PHOTOGRAPHS

PHOTOGRAPH #4

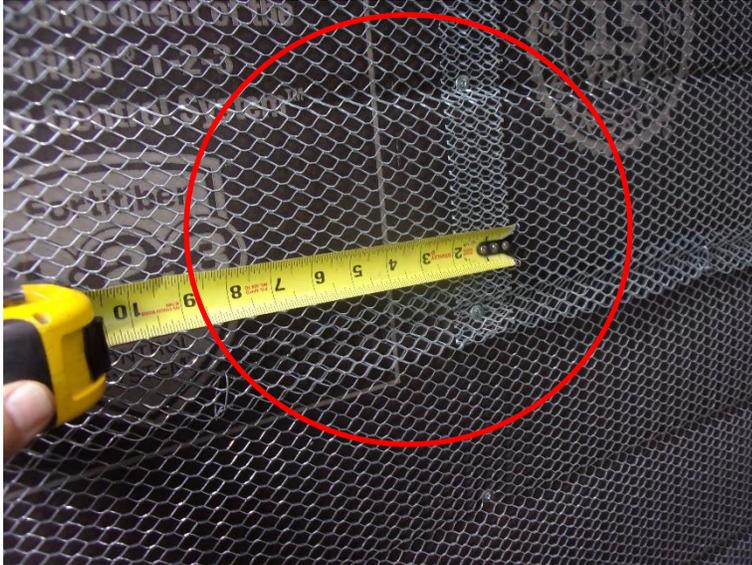
Contractor has straightened stucco stop, and finished stucco at patio.

PHOTOGRAPH #7

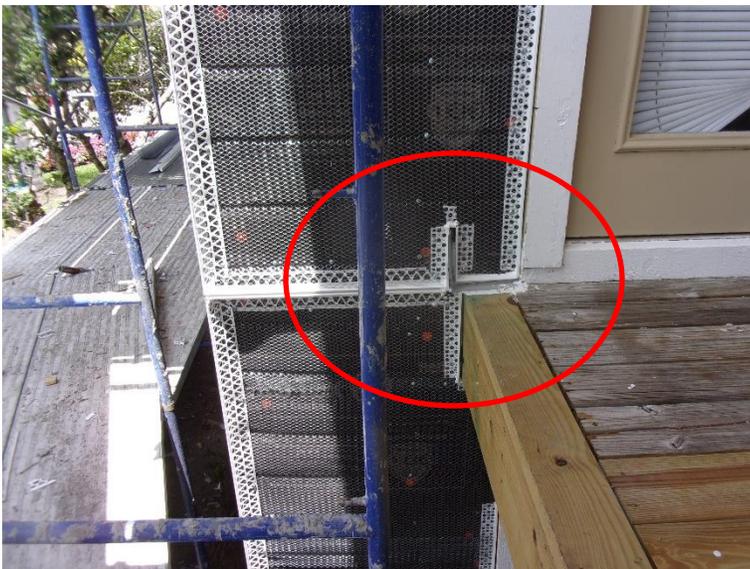
Stucco accessories at window bands in progress as per drawings.
